18 February 2022

**Re: DEVELOPMENT APPLICATION NO. DA/642/2020 – 11-19 FRENCHMANS ROAD, RANDWICK
ADDENDUM STATEMENT OF ENVIRONMENTAL EFFECTS
AMENDED DEVELOPMENT APPLICATION**

Figure 5: Extract from “Residents Rooftop Terrace – Level 2”
Source: Arcadia page 12

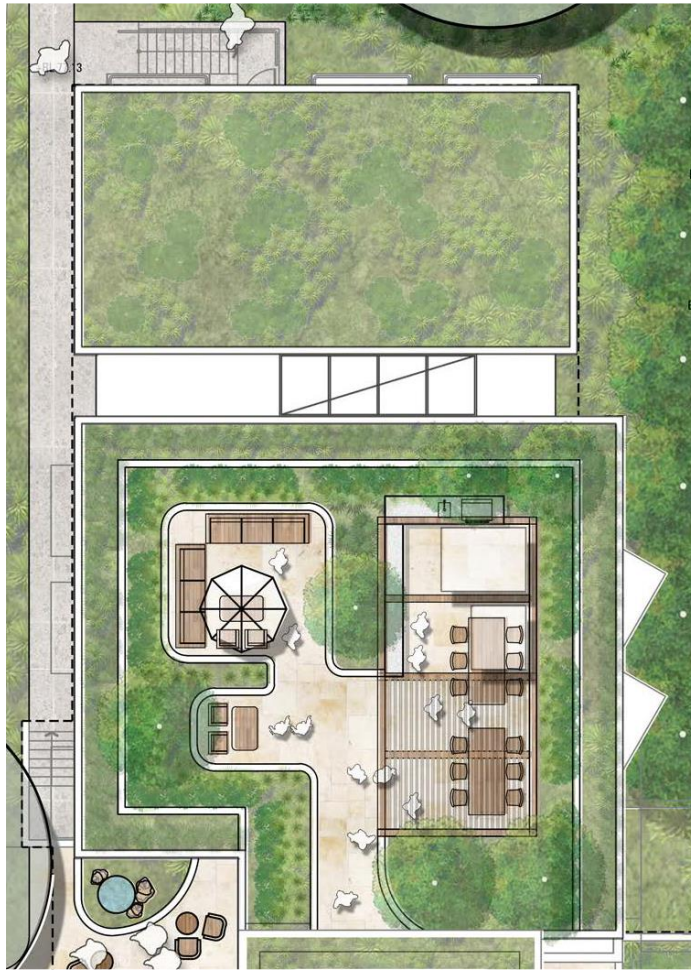
6. Level 2: Architectural Drawing No. DA07 Rev D dated 14 Feb 2022. All rooms / beds in the “north wing” on level 2 have been removed and the redesign now includes a roof over the level below. The McLennan Avenue frontage on level 2 of the north wing now proposed a “green roof” with a skylight to the corridor below to level 1 and then a terrace area accessed from the “Frenchmans Road wing” of Level 2 with this terrace area including a tiered landscaped planter bed surround to avoid overlooking.

The design of the Level 2 roof terrace is accessible to all residents within the proposed seniors housing development and includes a perimeter landscape solution as detailed on page 12 “Residents Rooftop Terrace – Level 2” of the Amended Landscape Architectural package.
